Access Compliance Report

Public Rights-of-Way

(Curb Ramps)

Intersection ID: N/A	Main Street: PORTOLA_CT	Cross Street: N/A	Location: W
ADA ID: A33C88594DDE	Ramp Type: Perp	Initial Pass/Fail: Fail	Overall Compliance: No
Severity Score: 12.5			
Codes/Mitigation Info/Possible Solution		Field Measurements/Component Compliance

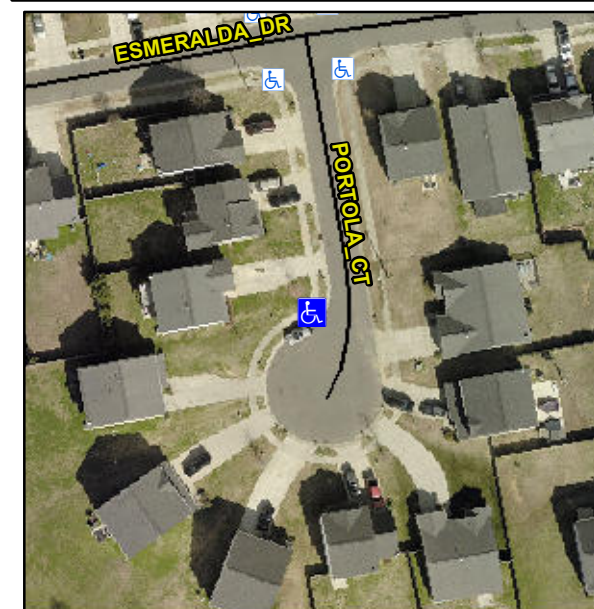
Not Found, R304.2.2

Compliance	Description	Data	Compliance	Description	Data
N/A	Ramp Length (in)	46.0	No	Ramp Slope (%)	9.8
Yes	Ramp Width (in)	48.0	Yes	Ramp XSlope (%)	0.7
N/A	Flare Type LT	N/A	N/A	Flare Type RT	N/A
N/A	Flare Slope LT (%)	N/A	N/A	Flare Slope RT (%)	N/A
N/A	Flare Traversable LT?	N/A	N/A	Flare Traversable RT?	N/A
N/A	Landing Length (in)	N/A	N/A	DWS Provided?	N/A
N/A	Landing Width (in)	N/A	N/A	DWS Contrast?	N/A
N/A	Landing Slope (%)	N/A	N/A	DWS Length (in)	N/A
N/A	Landing X Slope (%)	N/A	N/A	DWS Full Width?	N/A
N/A	Landing Curb? (Y/N)	N/A	N/A	DWS Offset (in)	N/A
N/A	Shared Landing?	N/A			
N/A	Gutter Ponding?	N/A	N/A	Gutter Slope (%)	N/A
N/A	Gutter Lip Ht (in)	N/A	N/A	Gutter X Slope (%)	N/A
N/A	Painted X Walk1?	No	N/A	Painted X Walk2?	N/A
	X Walk 1 Direction	To E		X Walk 2 Direction	N/A
N/A	X Walk 1 Width (in)	N/A	N/A	X Walk 2 Width (in)	N/A
	X Walk 1 Slope (%)	0.8		X Walk 2 Slope (%)	N/A
	X Walk 1 X Slope (%)	1.7		X Walk 2 X Slope (%)	N/A

Remove & Replace Entire Ramp.
